Microsemi Corporation

Product/Process Change Notification No: PCN17005

Subject: Important Changes in SmartFusion2 and IGLOO2 Devices

Summary of Changes: The PCN17005 notifies about several changes and impacts in SmartFusion2 and IGLOO2 devices.

The following figure illustrates the part marking specification for determining the die revision.

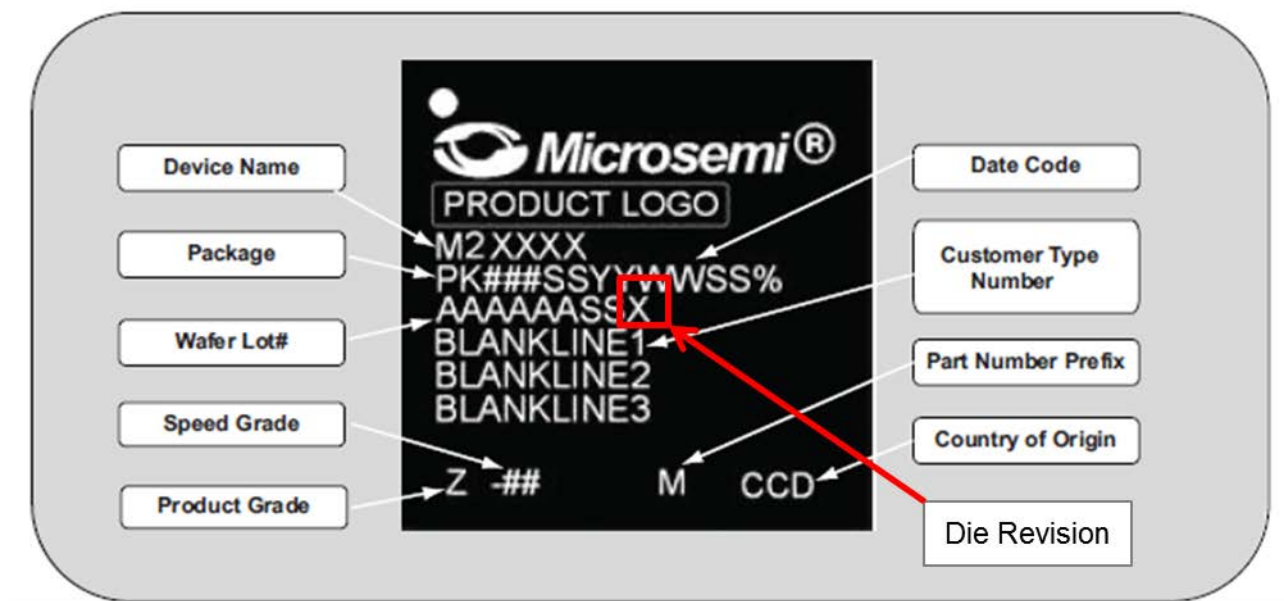
In both SmartFusion2 and IGLOO2 050 device densities, for die revisions 0 and 1, you can write to eNVM pages at addresses 0x6003FC80-0x6003FFFF. This area is reserved for storing the device certificate and digest information. Die revision 2 and above prevent the user from overwriting the device certificate and digest information. Firmware drivers and documentation have been updated to indicate proper usage.

In both SmartFusion2 and IGLOO2 005 and 010 device densities, for die revisions 0, you can write to eNVM pages at addresses 0x6003FC80-0x6003FFFF. This area is reserved for storing the device certificate and digest information. Die revision 1 and above prevent the user from overwriting the device certificate and digest information. Firmware drivers and documentation have been updated to indicate proper usage.

If you use eNVM at addresses, 0x6003FC80-0x6003FFFF, on the affected 005, 010, or 050 dies, you must move your data to another region in eNVM. You need to use the latest firmware drivers for writing to the eNVM.
